**Re: 49 CFR Part 573; Recall of Mercedes-Benz SLK (170) Tail Lamps**

Re: Recall Campaign **2006080005 Update and Customer Notification** - Replace Tail Lamps, Model 170 Model Year 1998 - 2004

Campaign No. 2006080005, February 2007

SUBJECT: **MODEL 170, MODEL YEAR 1998-2004**  
**REPLACE TAIL LAMPS**

Figure 1

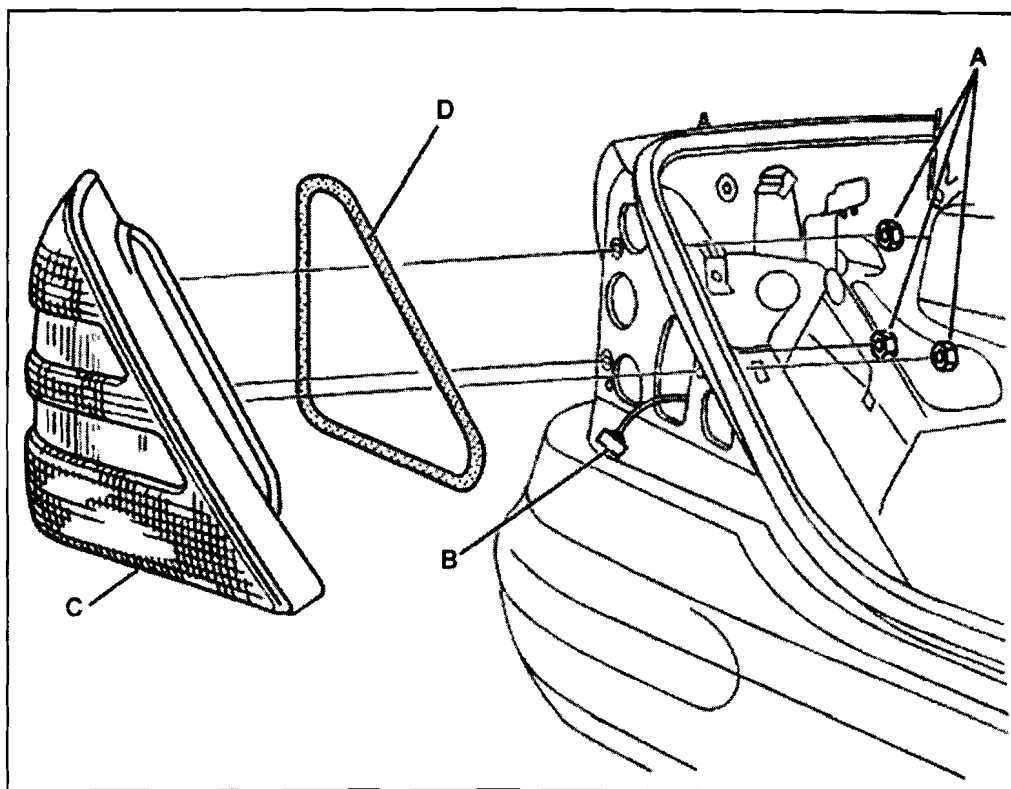
1. Open trunk lid.
2. Remove first-aid kit on left side; remove flap in wheelhouse paneling and CD changer (if applicable) on right side.
3. Remove nuts (A, Figure 1).
4. Disconnect electrical connector (B).
5. Replace tail lamps (C) on both sides of vehicle.

Ensure to install and position seal (D) correctly when installing new tail lamp.
